U.S. NUCLEAR REGULATORY COMMISSION

STANDARD REVIEW PLAN

3.2.2 SYSTEM QUALITY GROUP CLASSIFICATION

DRAFT Rev. 2 - April 1996

FIGURE A-1 EVOLUTIONARY BWR MAIN STEAM SYSTEM QUALITY GROUP AND SEISMIC CLASSIFICATION DIAGRAM

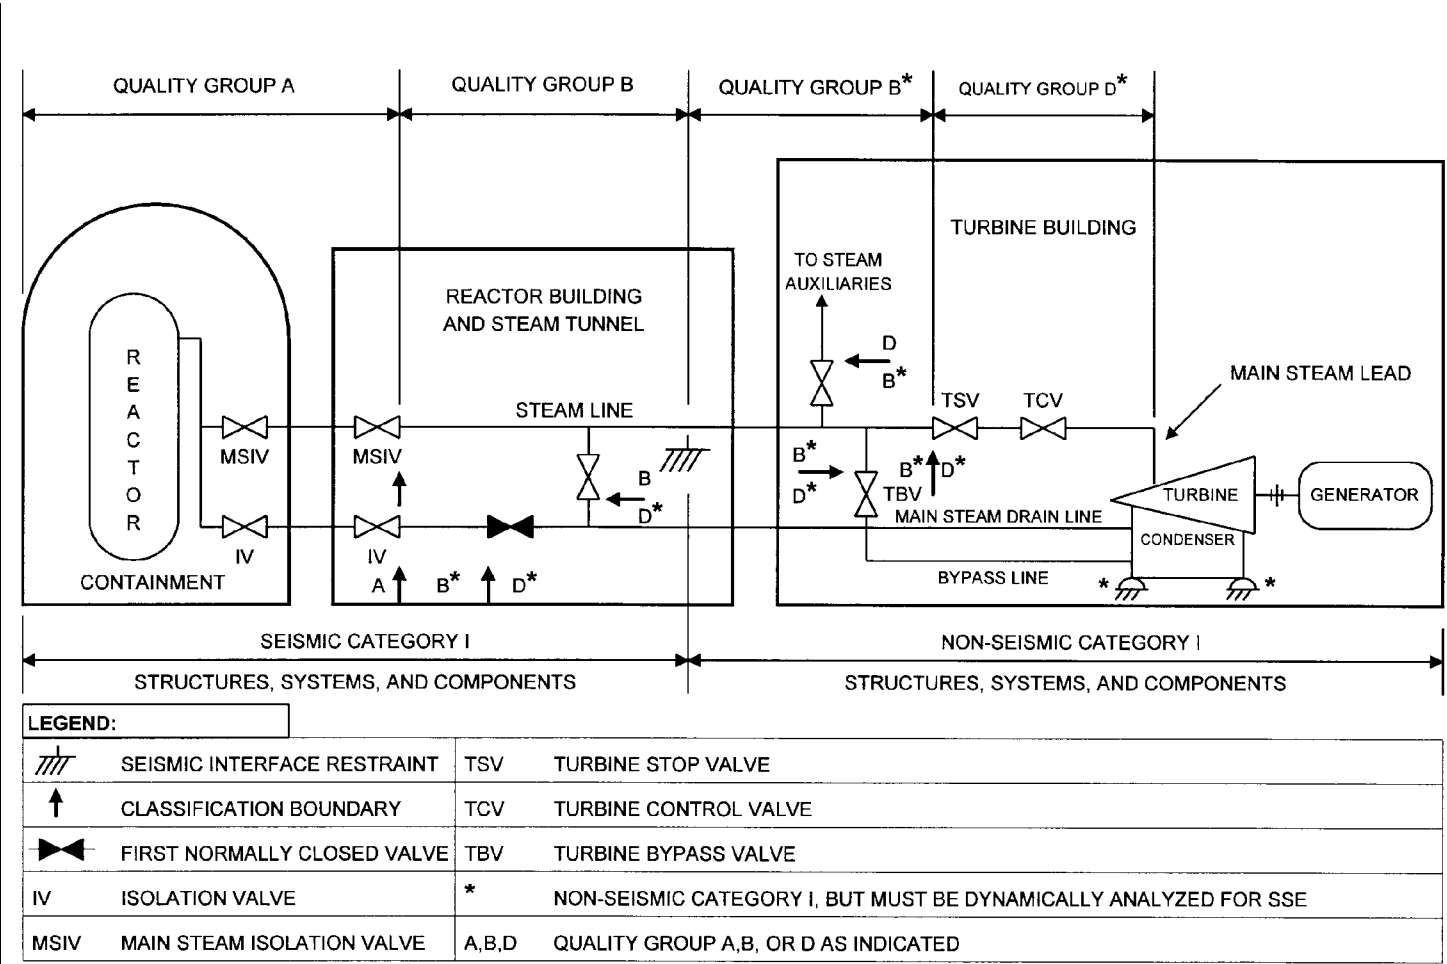
109.	Integrated Impact 1323	Added reference to classification criteria for BWRs without an MSIVLCS that take credit for fission product hold-up in the main steam lines. Also included new Figure A-1 at the end of Appendix A.

- ⁴ Acceptable design and classifications for BWR main steam piping and components, including those comprising main steam isolation valve leakage hold-up and retention paths, as illustrated in Figure A-1, are as follows:

- a. The "First Valve" in Table A-1, Item 2 refers to the first normally closed valve.
- b. The main steam line piping from the outermost containment isolation valve up to the seismic interface restraint should be classified as seismic Category I, as should connecting branch lines up to the first normally closed valve. The seismic interface restraint must provide a structural barrier between the seismic Category I portions of main steam piping in the reactor building and non-seismic Category I portions of such piping in the turbine building. The seismic interface restraint must be located inside a seismic Category I building. Main steam line piping from the seismic interface restraint up to, but not including the turbine stop valve (including branch lines to the first normally closed valve) and steam drain line piping from the outermost containment isolation valve to the condenser hotwell should be classified and analyzed as described in 4.c below. All pertinent quality assurance requirements of Appendix B to 10 CFR Part 50 apply to the main steam line piping from the seismic interface restraint up to, but not

including, the turbine stop valve (including branch lines to the first normally closed valve).
